### APPEAL SUMMARY

**Status:** Decision Rendered - Reconsideration of ID 22007

<b>Appeal ID:</b> 22204	<b>Project Address:</b> 5060 N Greeley Ave
<b>Hearing Date:</b> 12/11/19	<b>Appellant Name:</b> Dannon Canterbury
<b>Case No.:</b> B-010	<b>Appellant Phone:</b> 503-928-6965
<b>Appeal Type:</b> Building	<b>Plans Examiner/Inspector:</b> Brian McCall
<b>Project Type:</b> commercial	<b>Stories:</b> 5 <b>Occupancy:</b> S-2, A-2, A-3, B <b>Construction Type:</b> III-A, I-A
<b>Building/Business Name:</b> adidas North Building	<b>Fire Sprinklers:</b> Yes - Throughout
<b>Appeal Involves:</b> Reconsideration of appeal	<b>LUR or Permit Application No.:</b> 18-188494-CO
<b>Plan Submitted Option:</b> pdf [File 1] [File 2] [File 3] [File 4] [File 5]	<b>Proposed use:</b> Office, Assembly, Parking

**Alternate 2 hour fire rated floor / ceiling assembly: Granted as proposed**

## A1.606

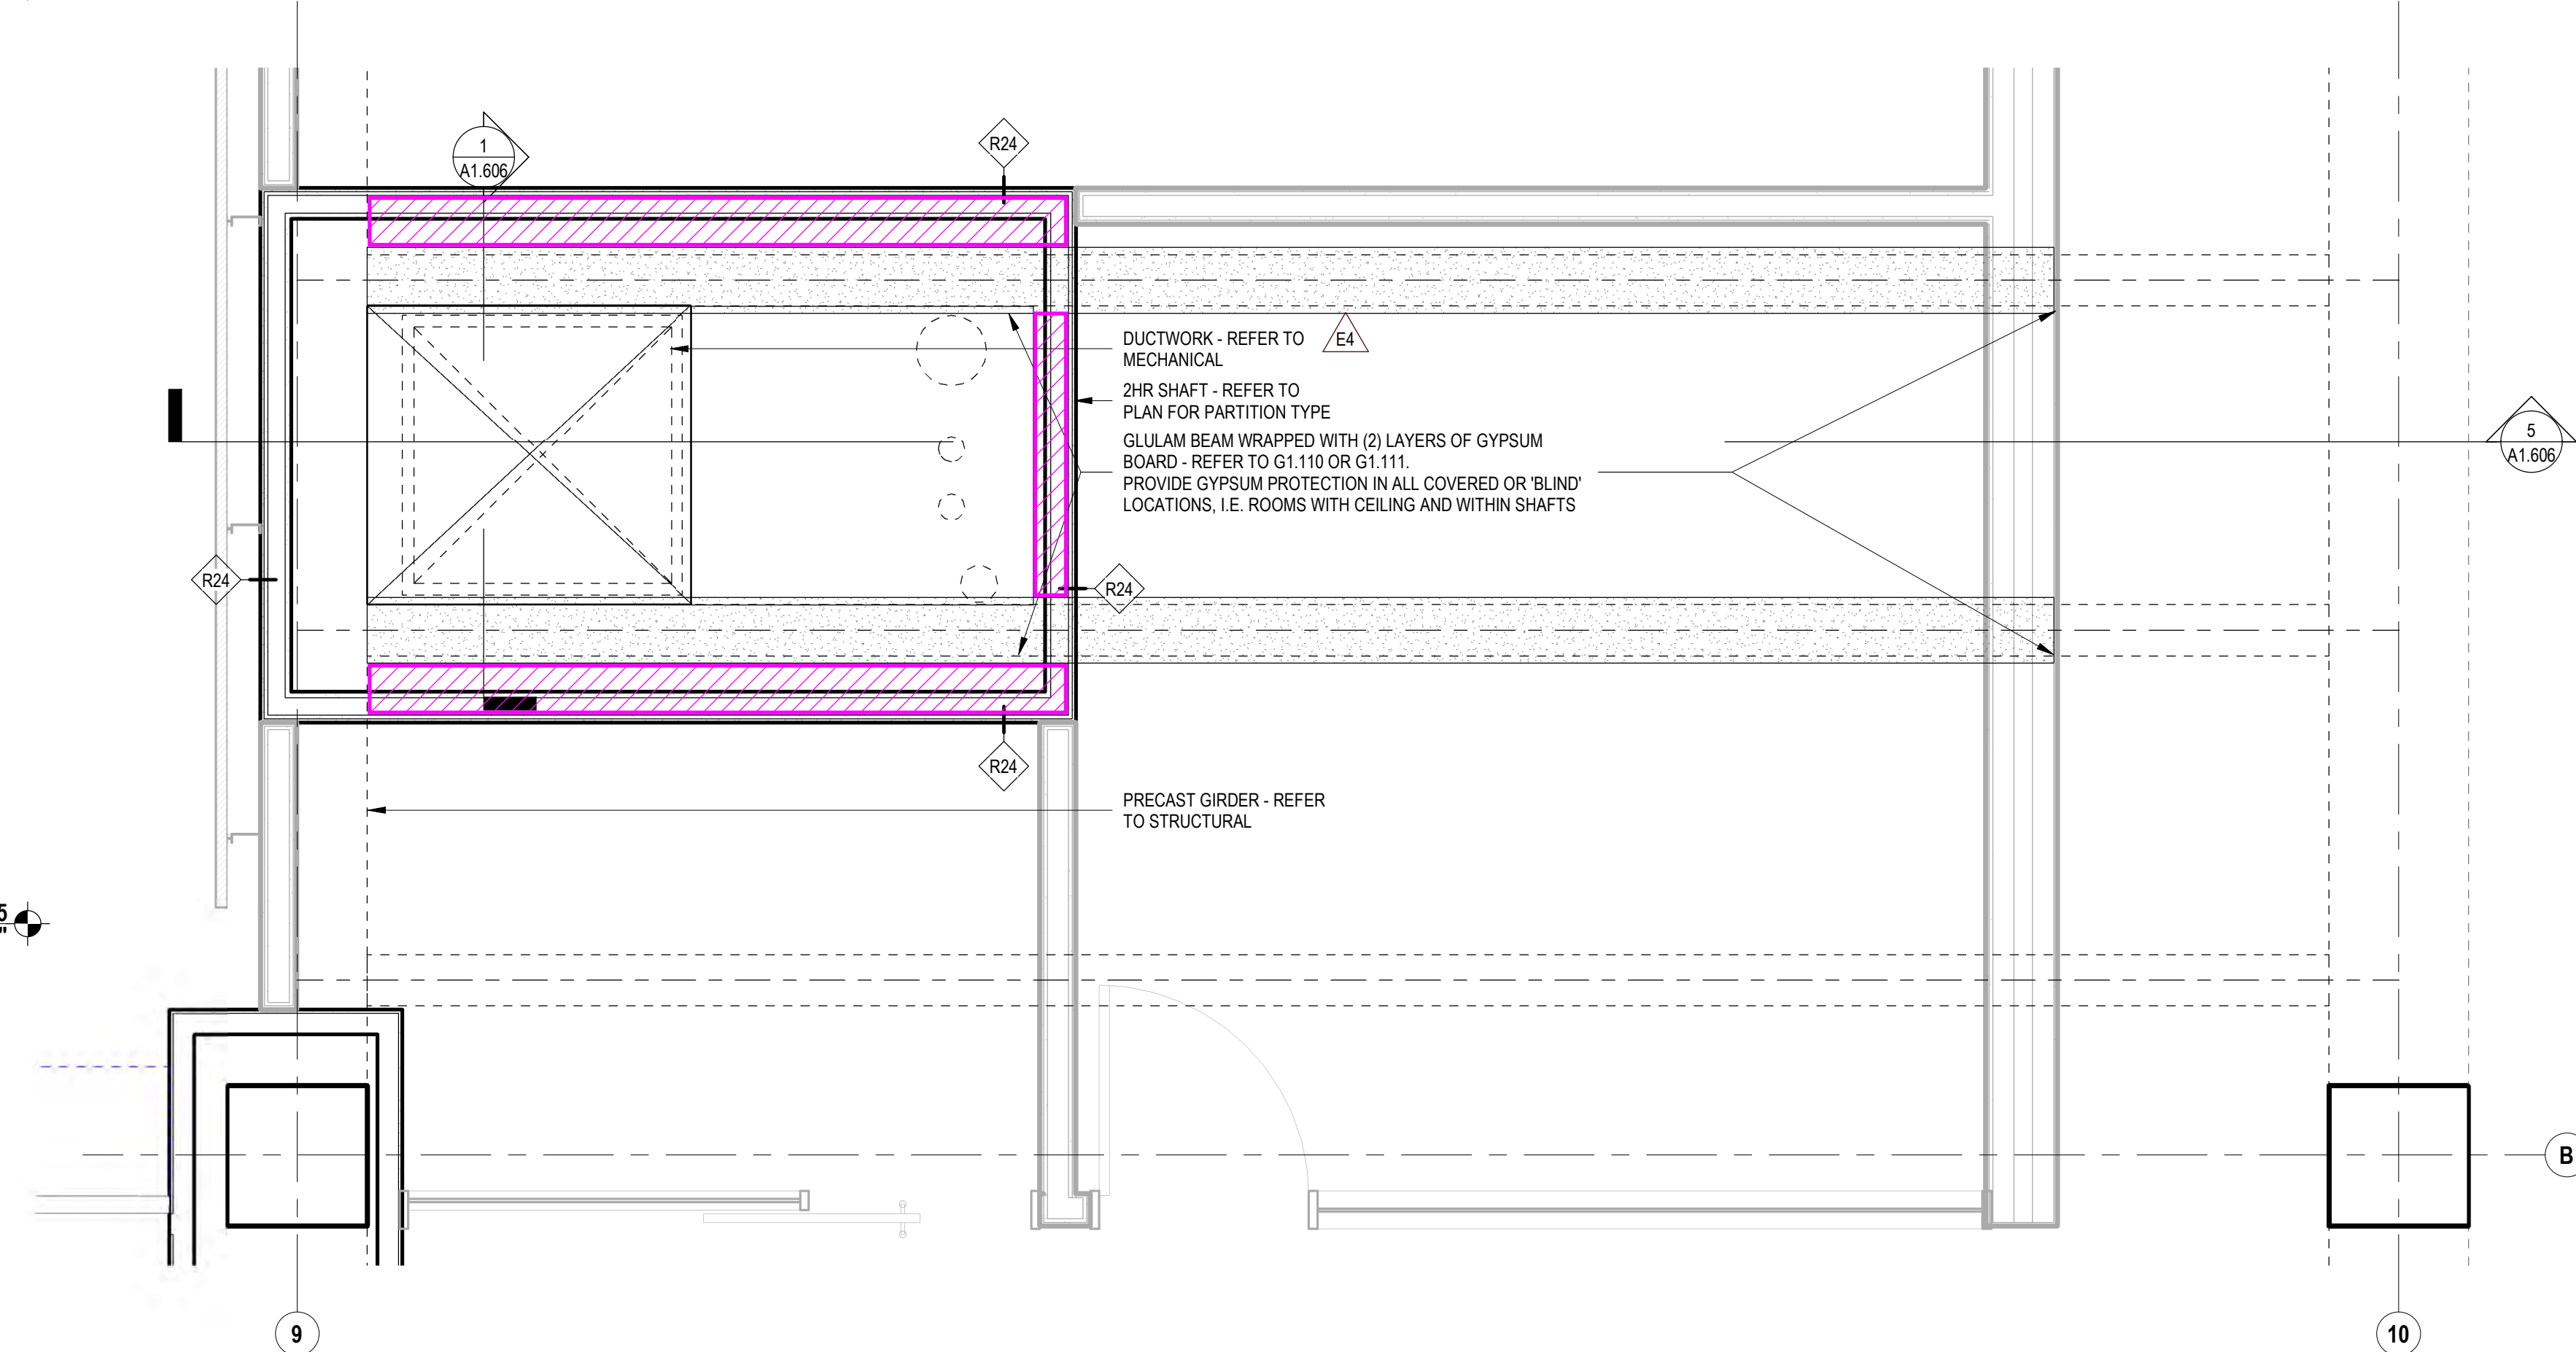
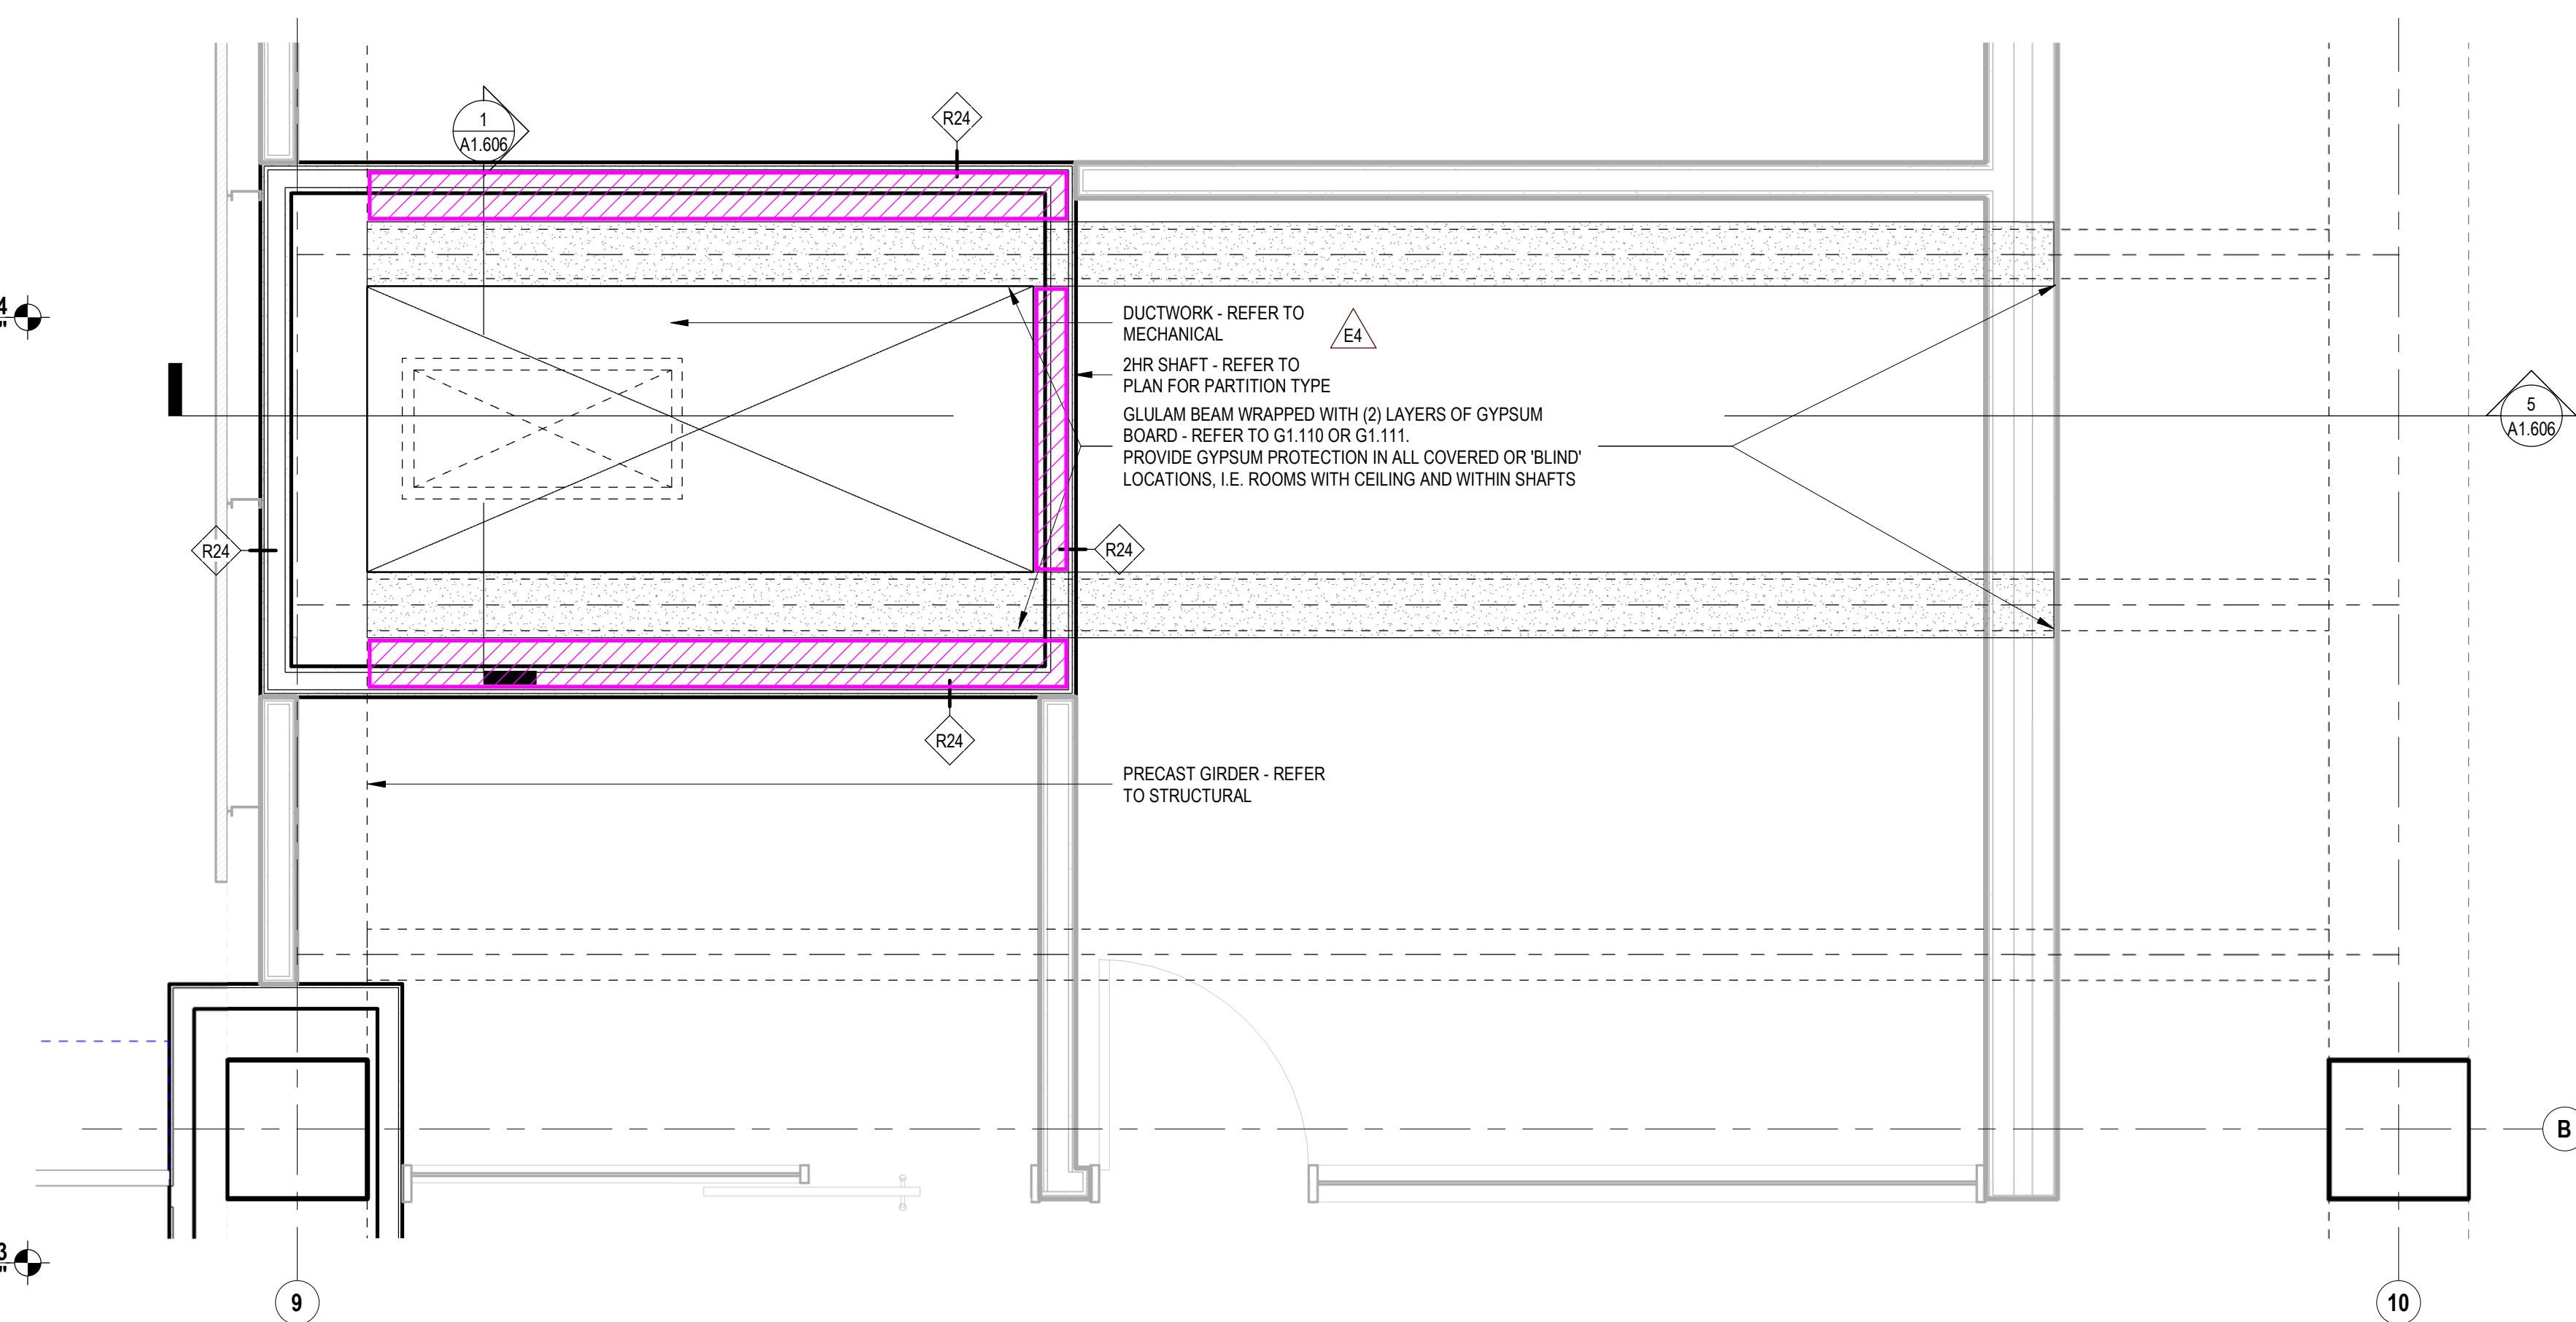
<b>Code Section</b>	OSSC 707.5 and 713.4
<b>Requires</b>	<p>OSSC 707.5.1 requires that supporting construction for a fire barrier be protected to afford the required fire-resistance rating of the fire barrier supported.</p> <p>OSSC 713.4 requires shaft enclosures to have a fire-resistance rating of not less than 2 hours where connecting four stories or more.</p>
<b>Proposed Design</b>	<p>This III-A construction type building consists of a structural frame of precast concrete columns and girders (3hr rated as presented during permit), glulam beams (1hr as presented during permit), 3-ply CLT (unaccounted contribution), and a concrete topping slab (1hr as presented during permit). Within the floors there are a number of shafts that are four stories or more which will be enclosed with a 2hr UL listed shaft wall assembly. Those shafts are structurally supported on either the 3hr rated precast concrete frame or 1hr rated glulam beams protected with two layers of 5/8" type 'x' gypsum board, raising their rating to 2hr (per NDS table 4.4.2.1).</p> <p>The presented design is to revise the extents of that gypsum wrap to include it at the glulam beams within the shafts and above spaces with ceiling but exclude it in the open office and lobby spaces where the beams are exposed to view.</p> <p>RECONSIDERATION:</p> <p>In addition to previous submission, the proposal is to provide additional protection to areas of the floor structure which directly support the 2-hour rated fire barriers at shaft locations. As previously indicated, floor structure is 3-ply CLT with concrete topping providing a 1-hour rating. At locations supporting 2-hour rated fire barriers, 2 layers of 5/8" type 'x' gypsum board would be added to the</p>

CLT decking to increase the floor structure's fire-resistance rating to 2-hours, per NDS table 4.4.2.1. See attached section drawings A1.603-A1.607 showing locations for consideration.

**Reason for alternative** The purpose of a shaft is to confine a fire (smoke, heat, and hot gases) to the floor of origin or preventing the fire from spreading to other levels. This purpose is met by protecting the glulam beams to achieve a 2hr fire-resistance within the shaft and in all covered or blind conditions where a fire could potentially propagate prior to initiating egress of the main spaces or affecting the structural integrity of the members and shaft.

The selected structural system generally limits the glulam beam spacing to 5'-0" on center, while shafts which house large mechanical ducts need to be larger than 5'-0" for fittings, dampers, etc. Spanning between concrete girders, some glulam beams exist entirely within the 2hr rated shafts and are rated to 2hrs (see attached reflected ceiling plans A1.701-A1.704). In locations where the glulam beams extend past the 2hr shaft enclosure, they are rated to 1hr fire-resistance, similar to the exposed glulam beams elsewhere in the project.

The Administrative Appeal Board finds that the information submitted by the appellant demonstrates that the approved modifications or alternate methods are consistent with the intent of the code; do not lessen health, safety, accessibility, life, fire safety or structural requirements; and that special conditions unique to this project make strict application of those code sections impractical.
